Statement regarding Alterations and Additions vs New Dwelling and Amendment details to DA2021/0381 - PAN87290 at 17 Ernest Street, Balgowlah Heights

Amendment details proposed for DA2021/0381 - PAN87290

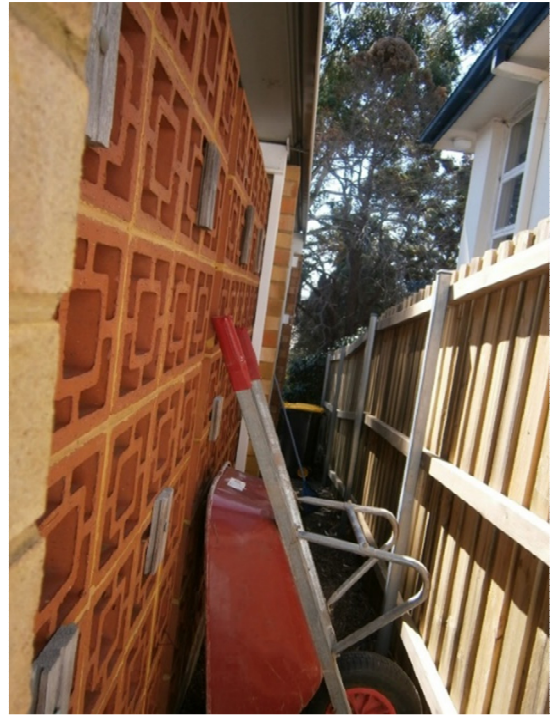
The challenge is that the proposed garage on the ground floor level essentially fills in the entire front left corner of the ground floor. This is a new structure to be built in place of the existing Carport (**see photos below**), so it needs to be shown as new work to both council and builders. The outline of the exiting residence and the Carport to be removed are shown dashed on all the elevations.

Similarly, the new Laundry and Toilet shows only the works that are infill of the old windows....the floor, ceiling and roof in this area are all to be retained. New walls are to be built over the existing walls as existing windows are removed to allow for the new Laundry and Toilet layout.
(see photos below)
